Access Compliance Report

Public Rights-of-Way

Intersection ID: 20203	Main Street: LANSING_DR	Cross Street: WINGRAVE_DR	Location: NE
ADA ID: B17DF53DB70D	Ramp Type: PerpDiag	Initial Pass/Fail: Fail	Overall Compliance: No
Severity Score: 25			
Codes/Mitigation Info/Possible Solution		Field Measurements/Component Compliance

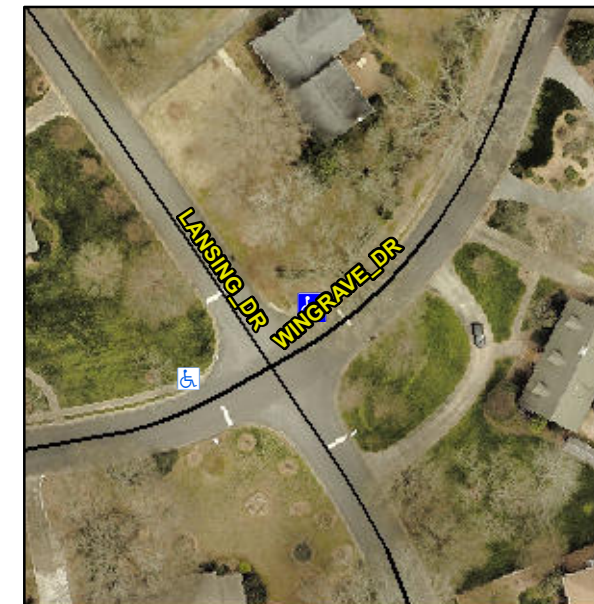
Not Found, R304.2.2, R304.5.3

Compliance	Description	Data	Compliance	Description	Data
N/A	Ramp Length (in)	48.0	No	Ramp Slope (%)	9.2
Yes	Ramp Width (in)	48.0	No	Ramp XSlope (%)	5.4
N/A	Flare Type LT	N/A	N/A	Flare Type RT	N/A
N/A	Flare Slope LT (%)	N/A	N/A	Flare Slope RT (%)	N/A
N/A	Flare Traversable LT?	N/A	N/A	Flare Traversable RT?	N/A
N/A	Landing Length (in)	N/A	N/A	DWS Provided?	N/A
N/A	Landing Width (in)	N/A	N/A	DWS Contrast?	N/A
N/A	Landing Slope (%)	N/A	N/A	DWS Length (in)	N/A
N/A	Landing X Slope (%)	N/A	N/A	DWS Full Width?	N/A
N/A	Landing Curb? (Y/N)	N/A	N/A	DWS Offset (in)	N/A
N/A	Shared Landing?	N/A			
N/A	Gutter Ponding?	N/A	N/A	Gutter Slope (%)	N/A
N/A	Gutter Lip Ht (in)	N/A	N/A	Gutter X Slope (%)	N/A
N/A	Painted X Walk1?	No	N/A	Painted X Walk2?	No
	X Walk 1 Direction	To SW		X Walk 2 Direction	To S
N/A	X Walk 1 Width (in)	N/A	N/A	X Walk 2 Width (in)	N/A
	X Walk 1 Slope (%)	2.3		X Walk 2 Slope (%)	2.9
	X Walk 1 X Slope (%)	0.3		X Walk 2 X Slope (%)	0.1

Remove & Replace Curb Ramp With Two New Directional Ramps or Equivalent.
